DEFENSE NUCLEAR FACILITIES SAFETY BOARD

Staff Issue Report

SUBJECT: Design Basis Earthquake Ground Motion Criteria for the Hanford Site and Waste Treatment Plant

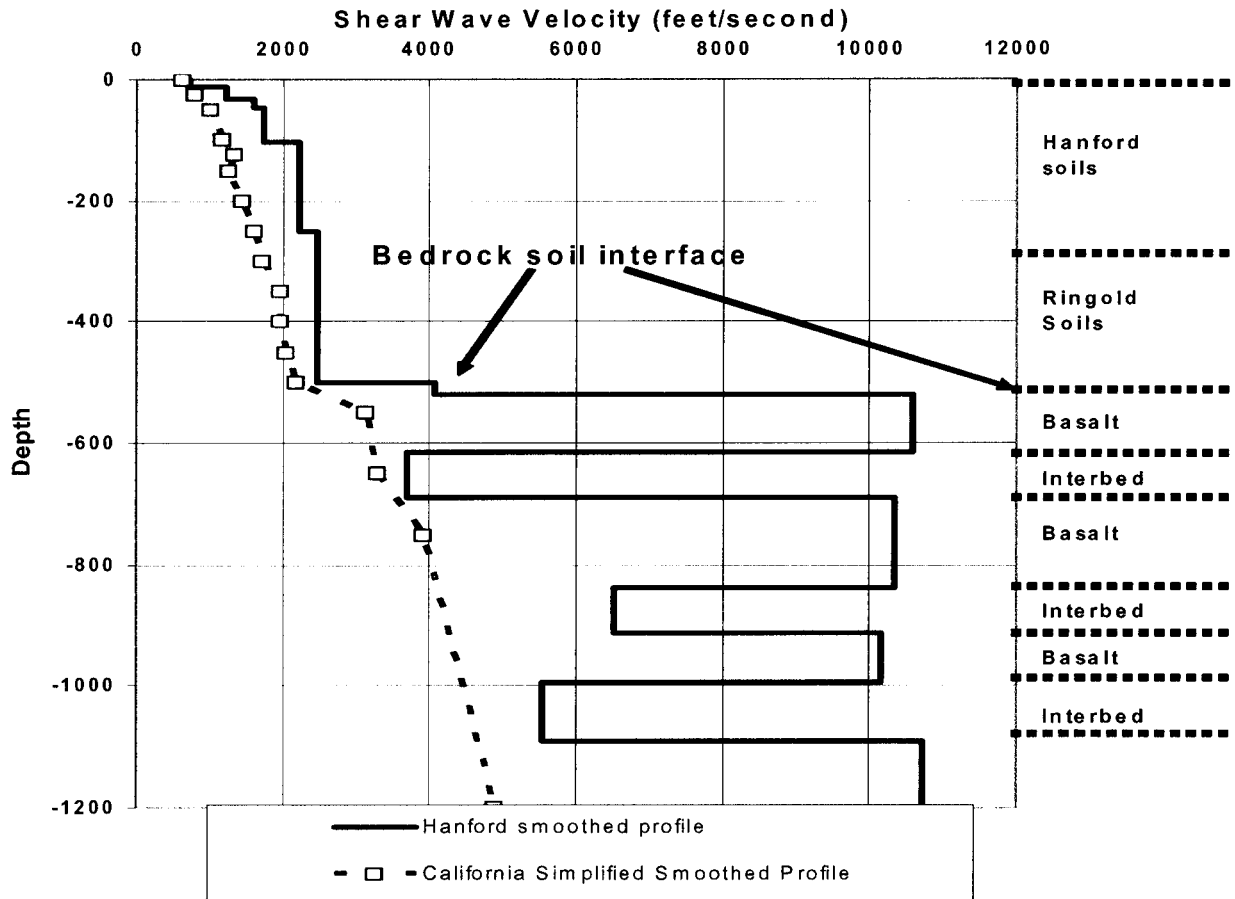
The Board's staff developed Figure 1 from these site response analyses to illustrate the V_s profile for California and the V_s profile used for the Hanford site. It is important to note that the Hanford bedrock V_s profile shown in Figure 1 is based on velocity data taken ~20 km from the WTP site.

However, the Hanford bedrock is not continuous, as seen by the bedrock interbeds shown in Figure 1. The 1996 analysis predicted a significant energy reduction resulting from the arrangement of these bedrock interbeds. This energy reduction counteracted the large soil amplification, resulting in comparable ground motion for Hanford relative to California. Thus the behavior of the bedrock interbeds plays a critical role in determining the site ground motion.
